Update Instructions

SP018/03/S

Title: Hardware check Motor Drive

Name	Material No.	Serial No.
UROSKOP D1 (LX)	97 85 023 G5347	01008 - 01060

Fig. 1

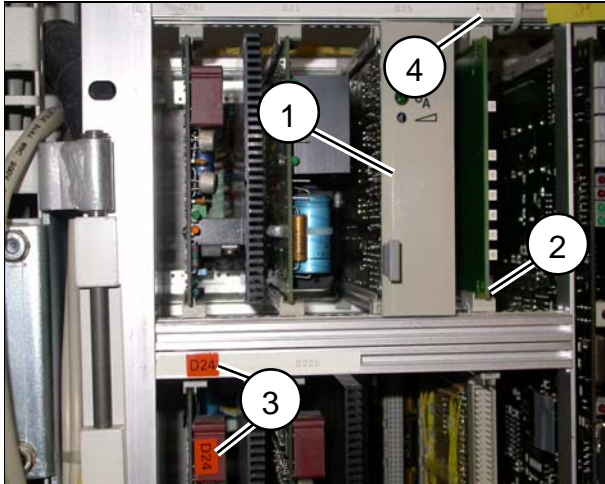
- Remove the board D25 (1/Fig. 1).
- Swivel out the control unit M20.
- Remove any EMC covers.
- Connect the socket connector for board D23 to the slot next to board D25 (2/Fig. 1). Use the supplied slotted cap screws for this. If there are no threads available in the control frame, then use self-tapping screws M2.5 x 8 with Phillips head.
- Label the slot with D23 (4/Fig. 1).
- Attach guide rails.
- Plug board D25 back in.
- Check DIP switches on board D23. Switches 3, 4 and 6 must be "ON". The position of all other switches is arbitrary.
- Plug in board D23.

- Solder interconnecting wire 0.5 on board from socket connector X1 b4 (1/Fig. 4) to the 5th resistor (2/Fig. 3 and 2/Fig. 4) viewed from the socket connector.
- Stick label printed with the new part number 11 56 731 over the old part number 89 49 505 G5334 on board.
- Affix label D24 at position (3/Fig. 1).
- Cover old designation D20a on the frame with new label D24.

Fig. 2

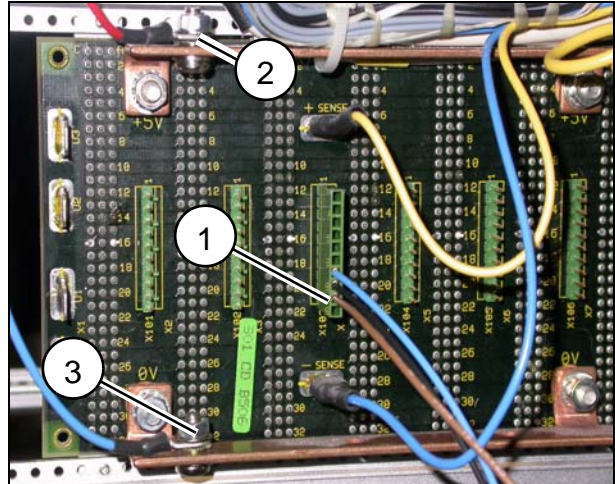
- Plug the brown lead from the socket connector D23 d8 into the 10-pin socket connector X103.9
- Screw fasten the red lead from socket connector D23 d2 onto the plus rail (2/Fig. 2)

- Screw fasten the blue lead from socket connector D23 d4 onto the minus rail (3/Fig. 2)
- Reattach the EMC covers, swivel in the control unit and fasten it with screws.

Fig. 3

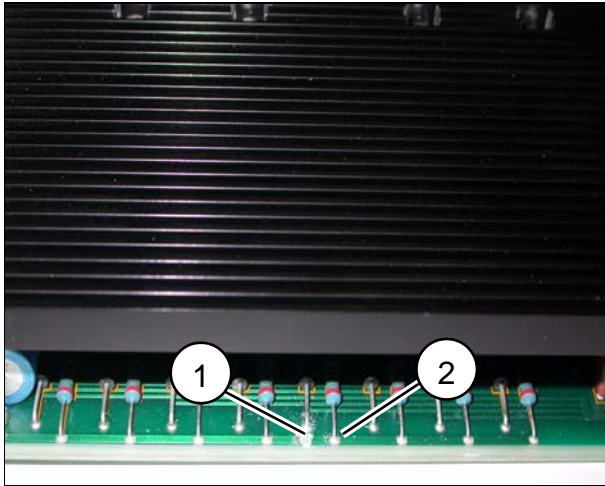
- Remove board D20a.
- Separate the connection from socket connector X1 b2 to b4 (1/Fig. 4) on the soldering side of the board and check the interruption with an ohmmeter.
- Interrupt the connection between the 4th and 5th resistor (1/Fig. 3) and check the interruption with an ohmmeter.

Fig. 5

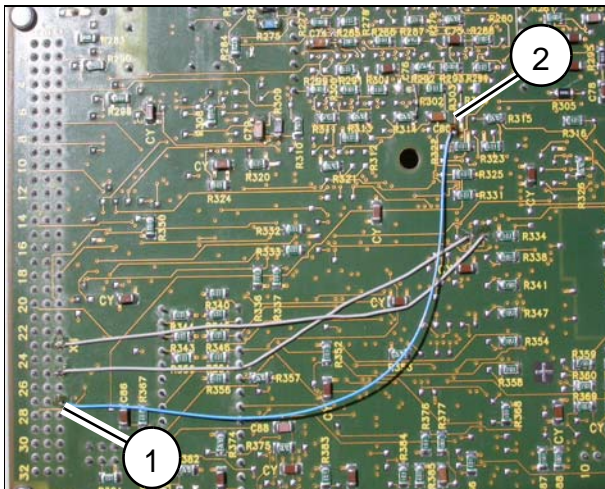
- On board D6, solder a 0.25 mm lead from X2 c27 (1/Fig. 5) to (2/Fig. 5). For a detailed view of the soldering point, see (1/Fig. 6).
